ADDENDUM #2
Electrical Enclosures & Fuel Station
Invitation to Bid: 13-011
6 March 2013

NAVY MOLE FUEL STAT. / FLOATING DOCK IMPR.
KEY WEST, FLORIDA
NAVAL FACILITIES ENGINEERING COMMAND
SOUTH DIVISION - CHARLSTON, SOUTH CAROLINA

DEPARTMENT OF THE NAVY
NAVAL FACILITIES ENGINEERING COMMAND
NAVAL FACILITIES ENGINEERING COMMAND SOUTHEAST
NAVAL AIR STATION JACKSONVILLE
KEY WEST, FLORIDA
NAVAL AIR STATION KEY WEST
MOLE PIER ELECTRICAL ENCLOSURES
DETAILS

1 LOCATION SITE PLAN
1" = 30'

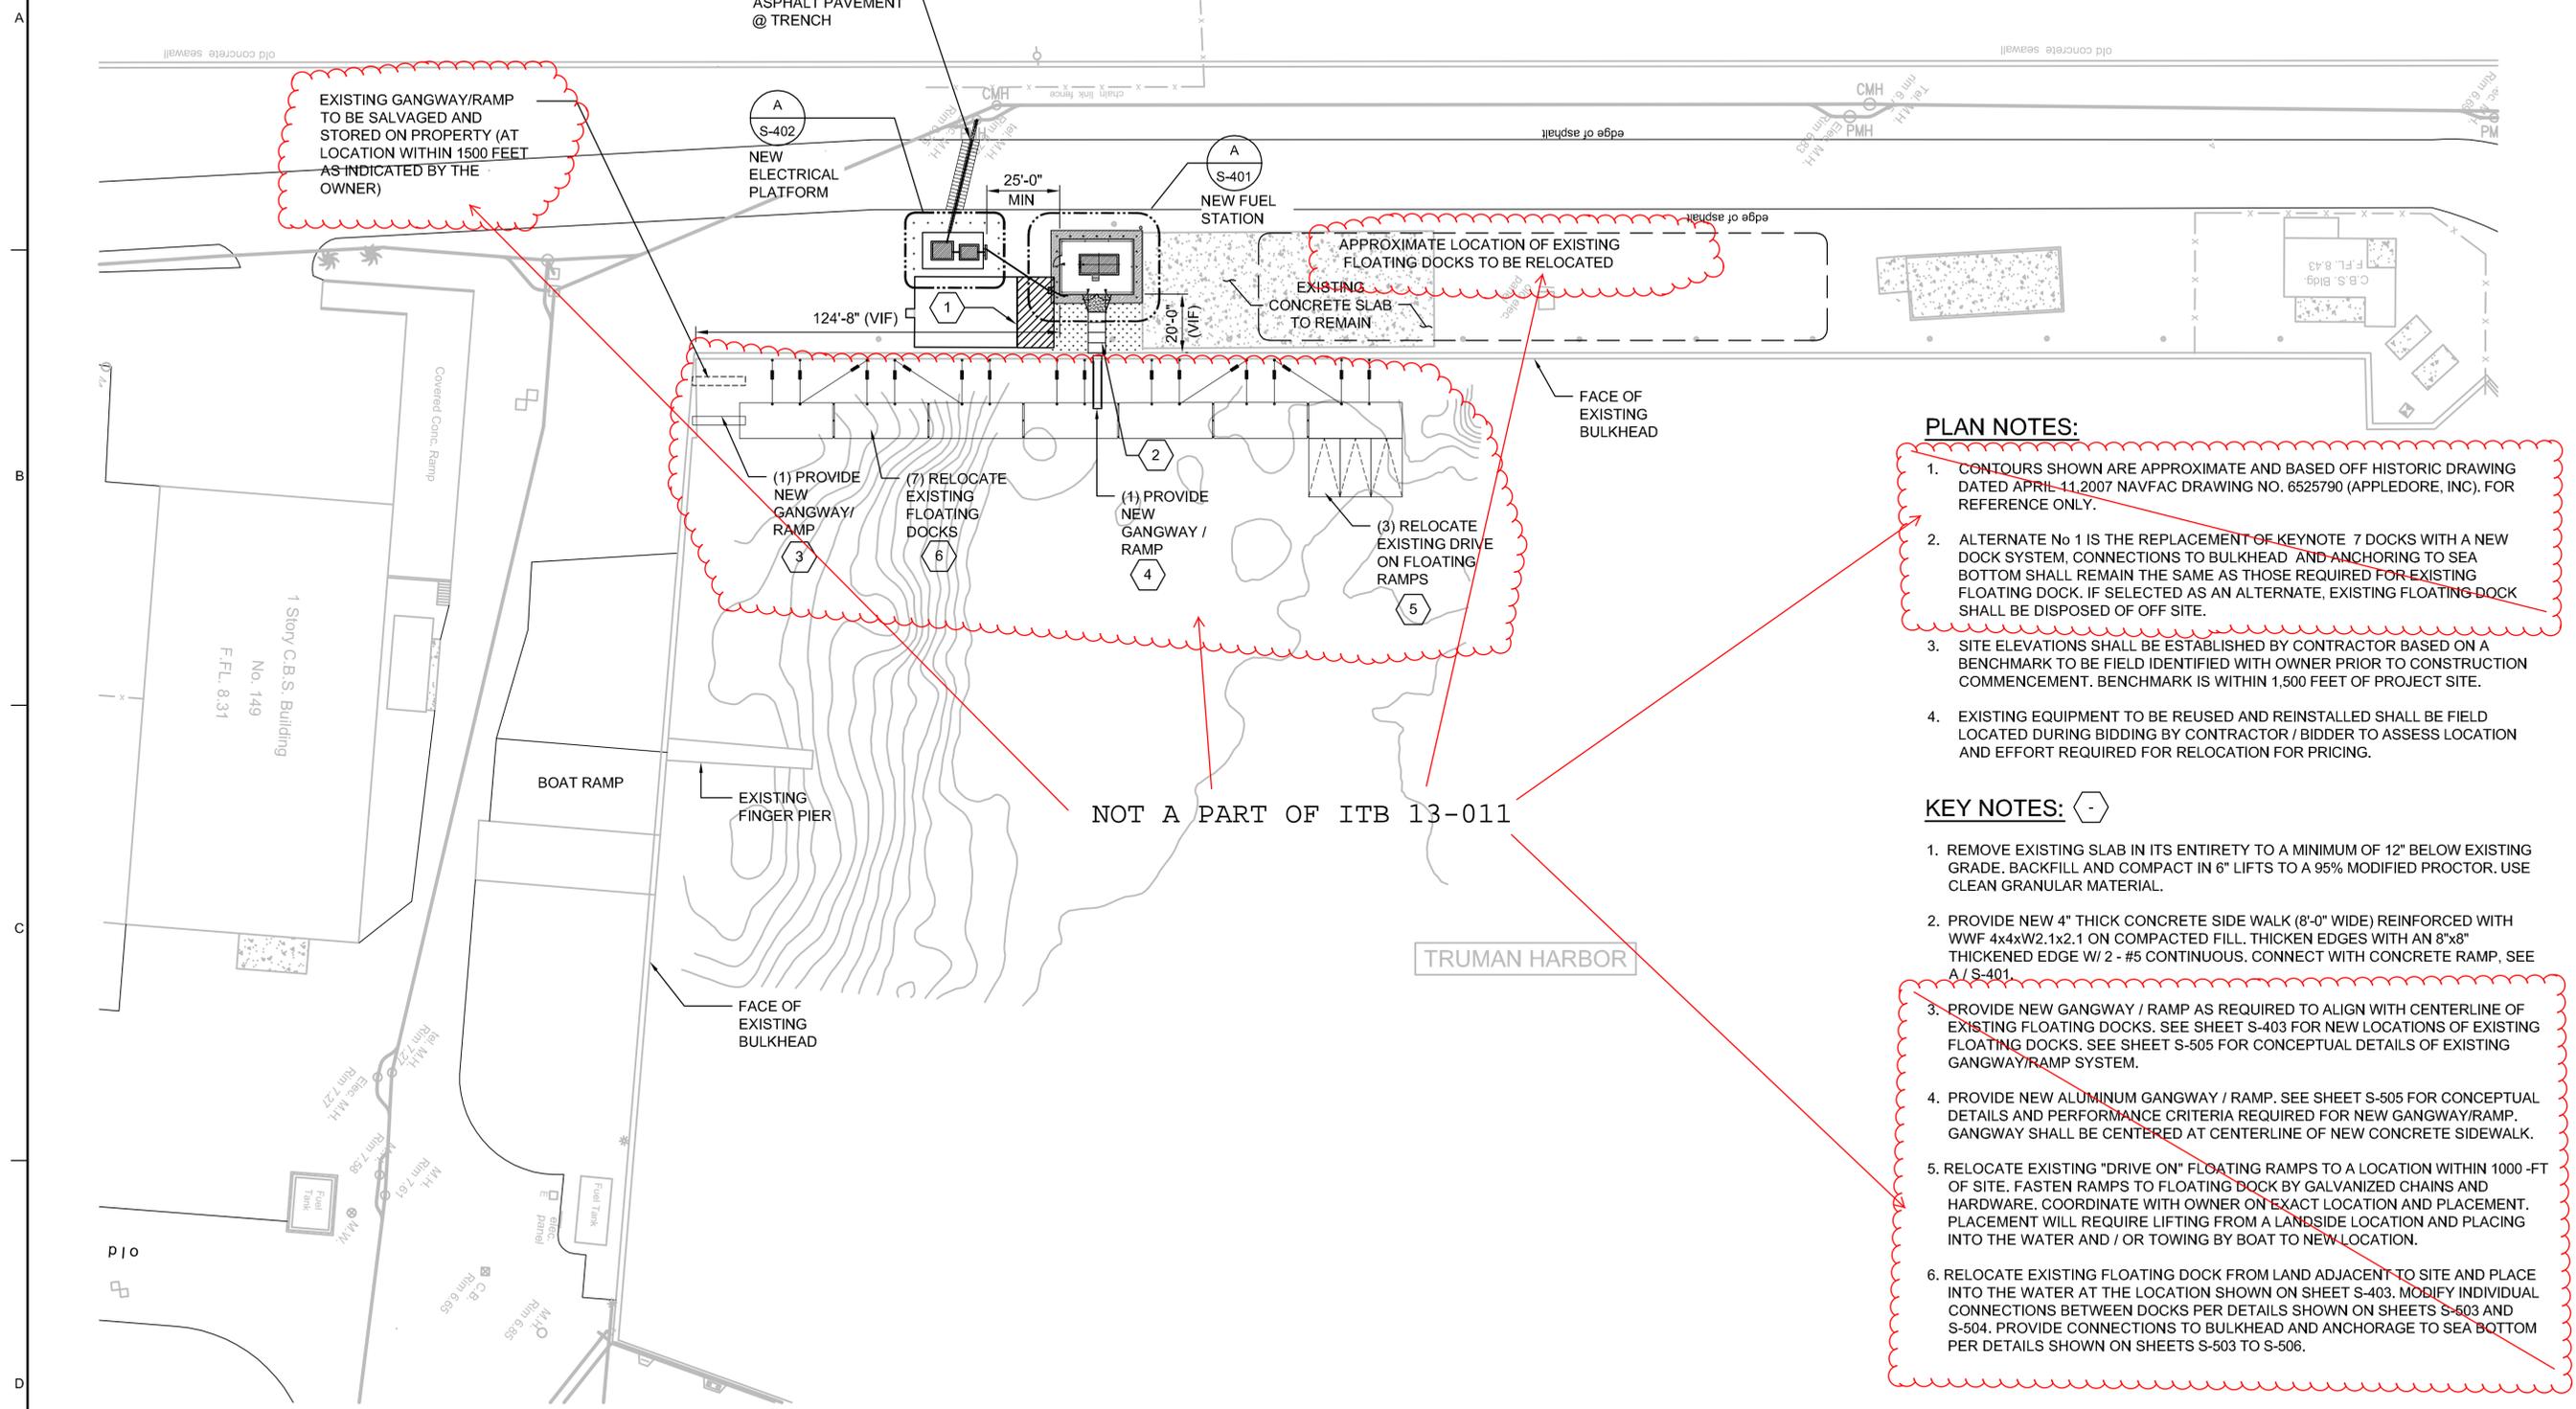
- b. Portions of Sheets S101 and E101 indicated are not a part of this project.
 - c. Any reference to “Floating Dock” and work associated with “Floating Dock” is not a part of this project.

SITE
**FLOATING DOCK CONNECTION
DETAILS SHEET 1**

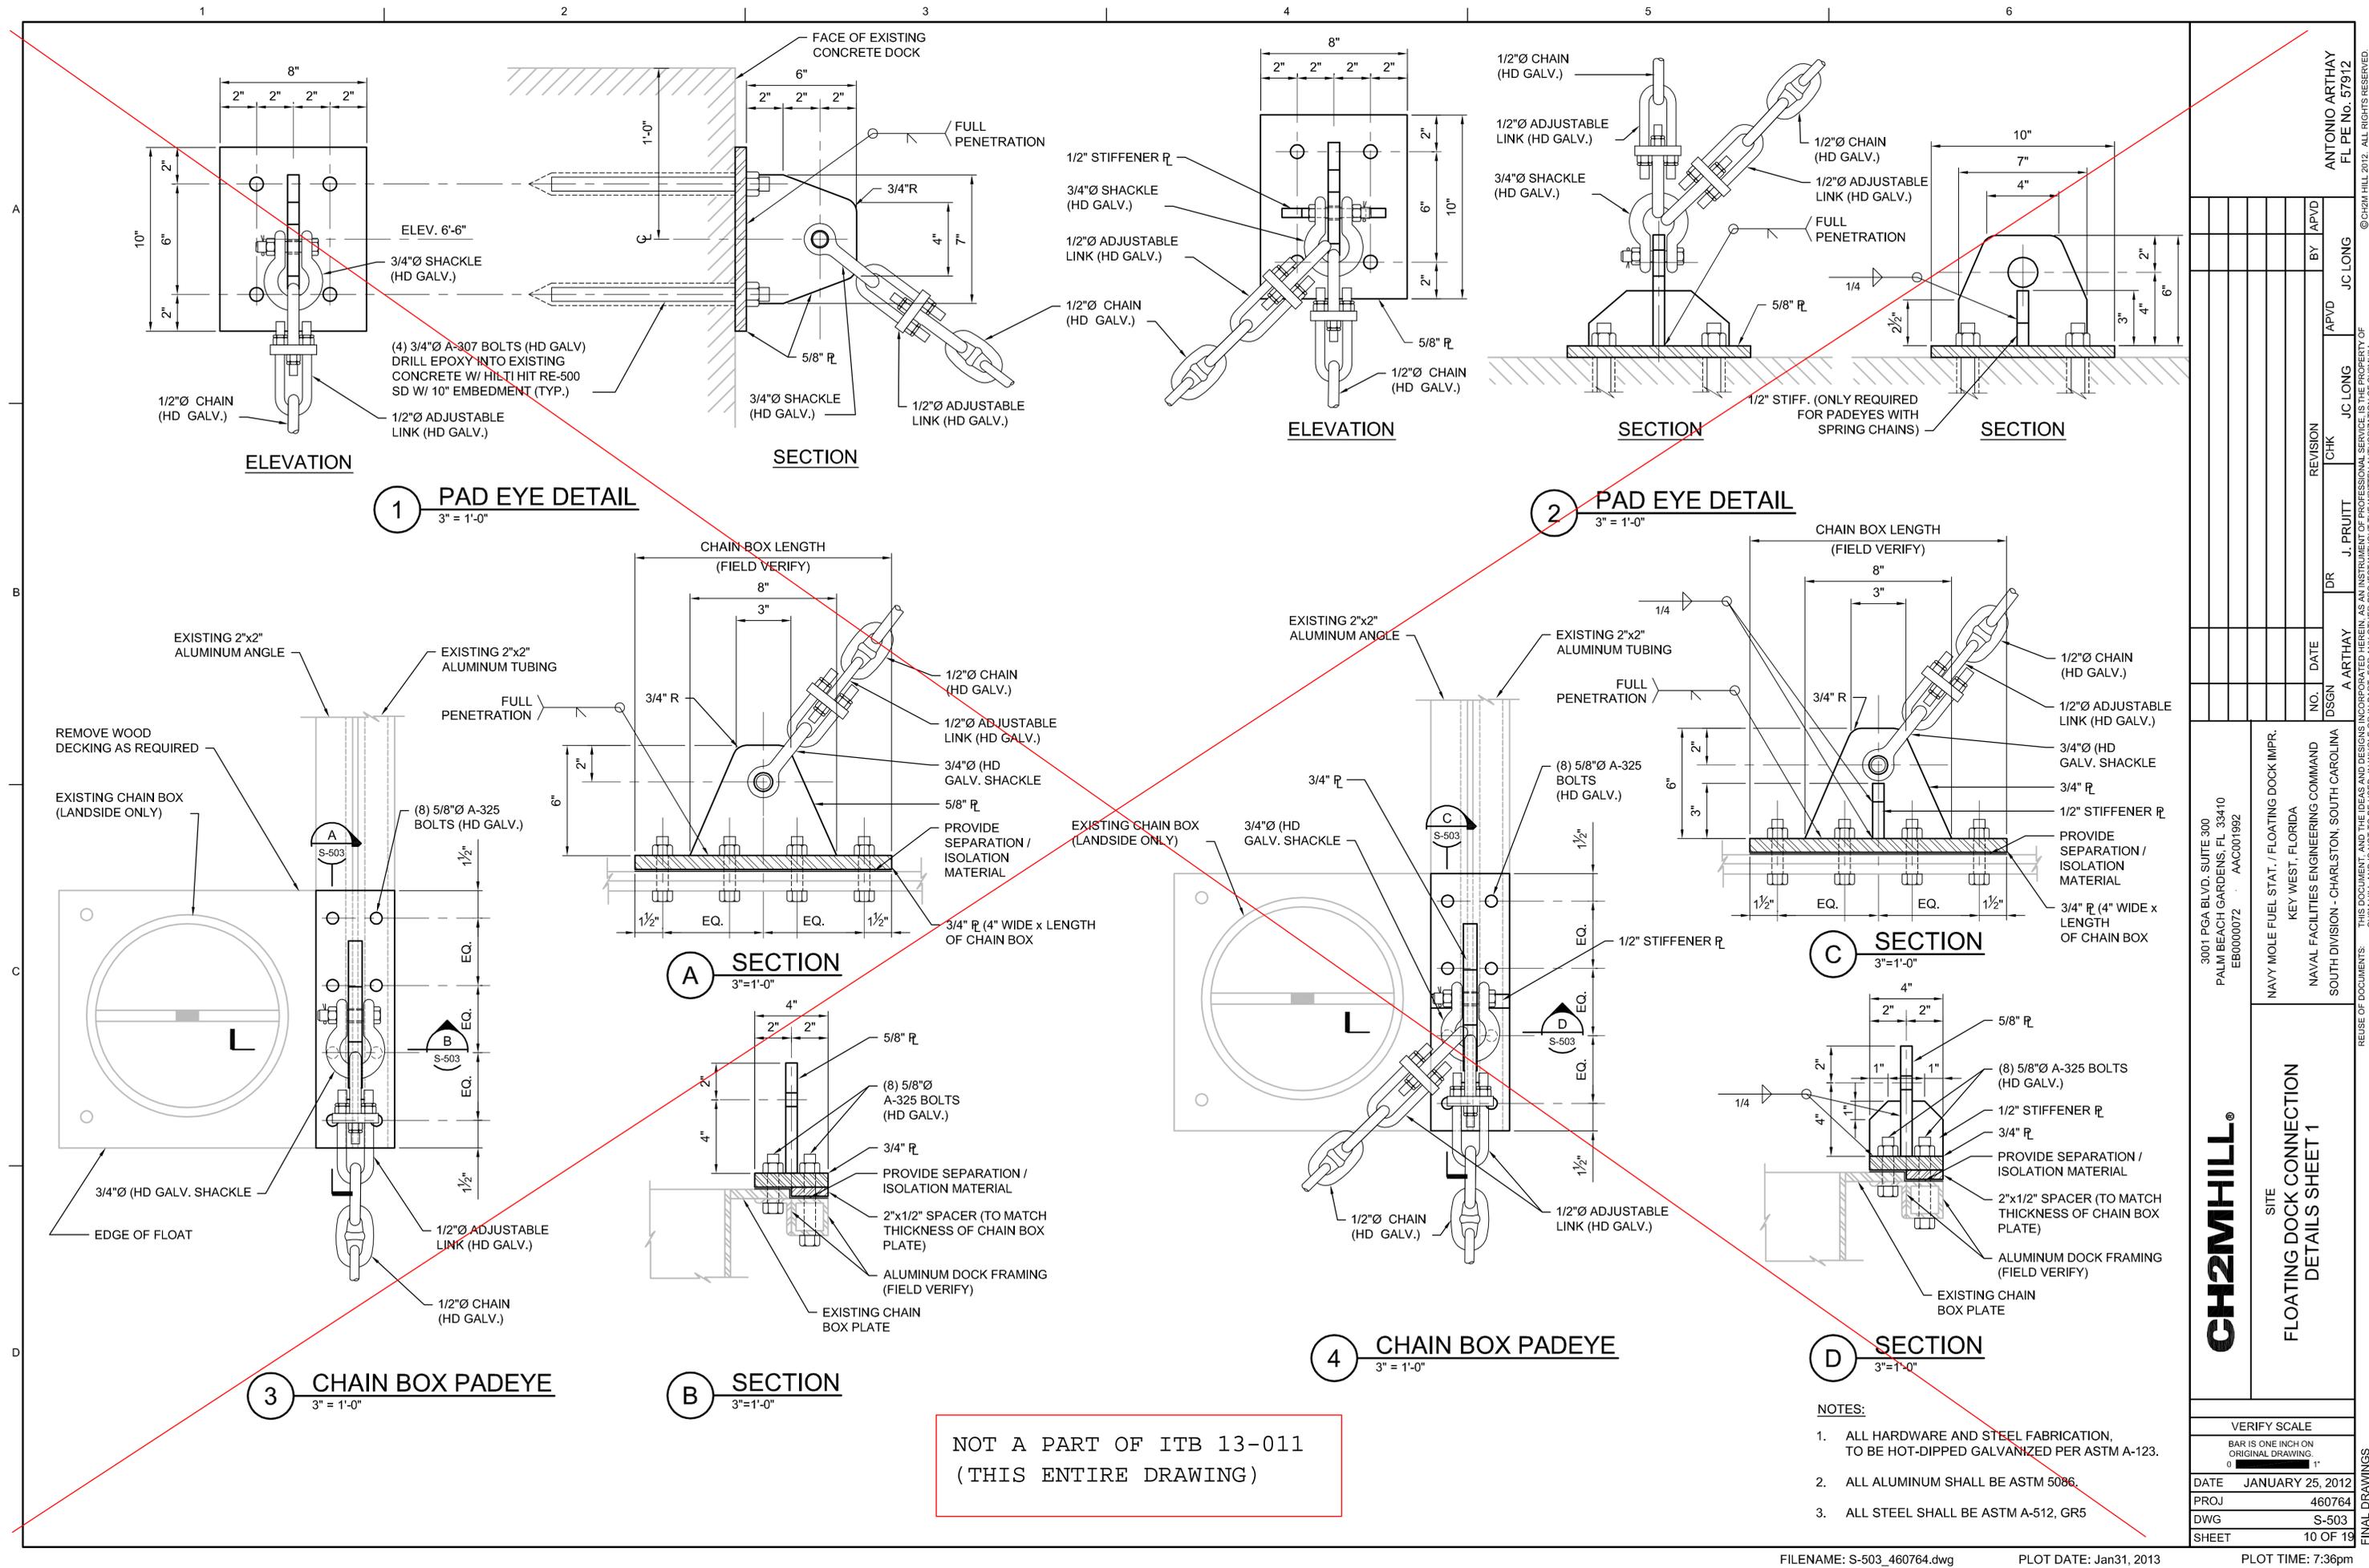
1. Replace Section F of Part 3 – Plans & Specifications with the attached (19 pages).
 - a. All work depicted on Sheets S403, S503, S504, S505, S506, S507, is to be excluded from this project in its entirety.

NOT A PART OF ITB 13-011
(THIS ENTIRE DRAWING)

SITE
**FLOATING DOCK CONNECTION
DETAILS SHEET 2**

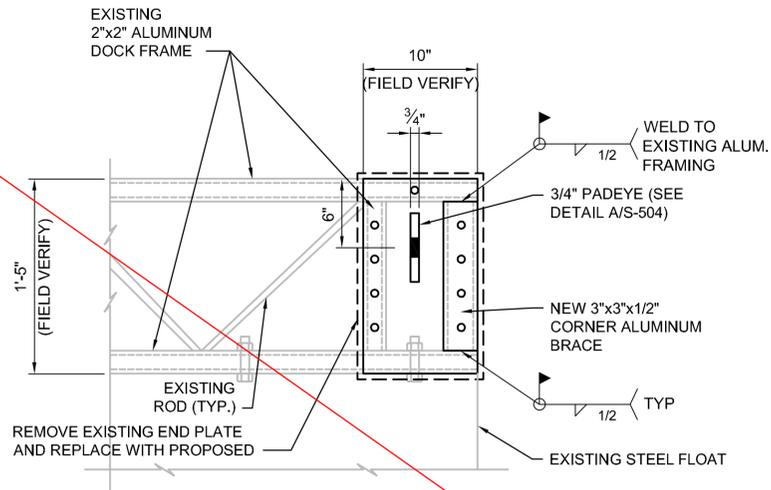
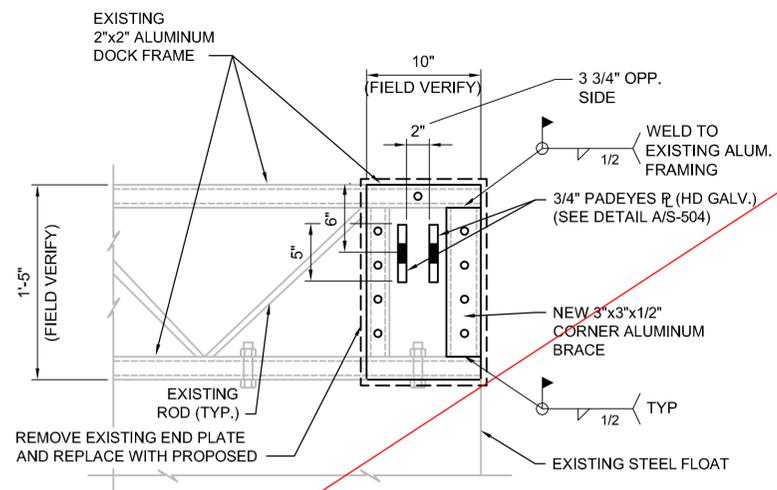
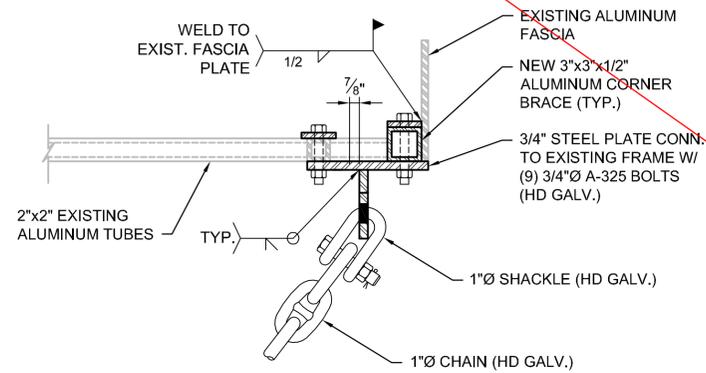
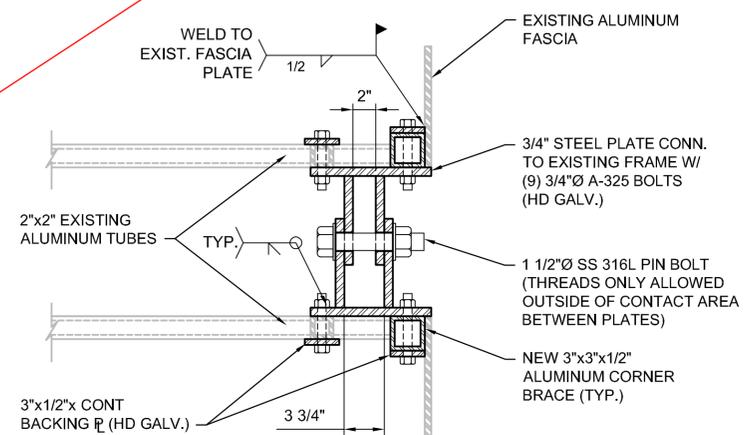
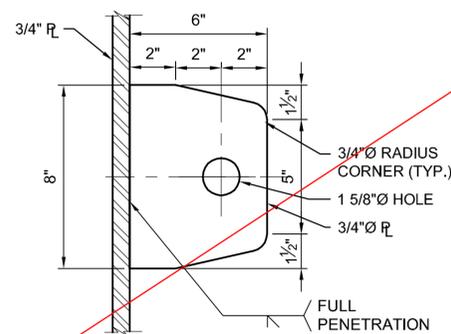
NOT A PART OF ITB 13-011
(THIS ENTIRE DRAWING)
